Work Order ID 96897

Item Name: Replacement Skidtube

DRAWING NO. D2650	TITLE 206/407 SKIDTUBE ASSEMBLIES	REV. F	DART AEROSPACE LTD ENGINEERING ORDER		D.E.O. NO. D2650-F-1	SHEET NO. SHEET 1 OF 1	SCALE NTS
DRAWN <i>[Signature]</i>	CHECKED A.P.	MFG. APPR. <i>[Signature]</i>	APPROVED <i>[Signature]</i>		DE APPR. <i>[Signature]</i>		
DATE 12.10.12	DATE 12.10.22	DATE 12.10.22	DATE 12.10.22		DATE 12.10.22

CHANGE C'BORED WELDED CROSSBOLT SPACERS TO SWAGED SPACERS

IS:

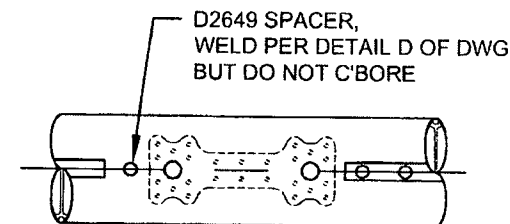
PARTS LIST IS AMENDED AS FOLLOWS:

QTY	QTY	QTY	QTY	PART NUMBER	DESCRIPTION
-1	-3	-5	-7		
1	1	0	0	D2649	CROSS BOLT SPACER
16	17	19	23	D4720-1	SPACER

**DETAIL B**

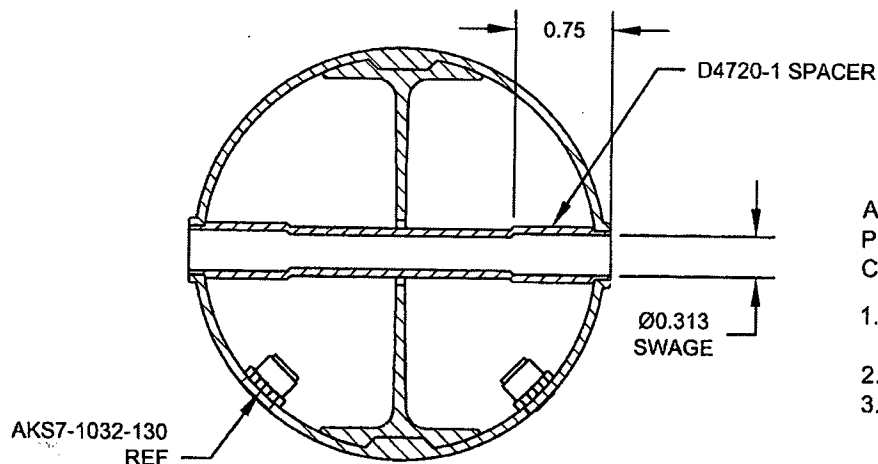
ADD DETAIL G BELOW, WHICH IS THE SAME SECTION VIEW AS DETAIL D OF DWG.

C'BORED HOLES ARE **NOW SWAGED** PER DETAIL G BELOW. FOR THE Ø0.375 HOLE THAT IS NOT C'BORED, WELD PER DETAIL D OF DWG (SEE AMENDED DETAIL B FOR REFERENCE).

AMENDMENT TO DETAIL B  
NOT TO SCALE
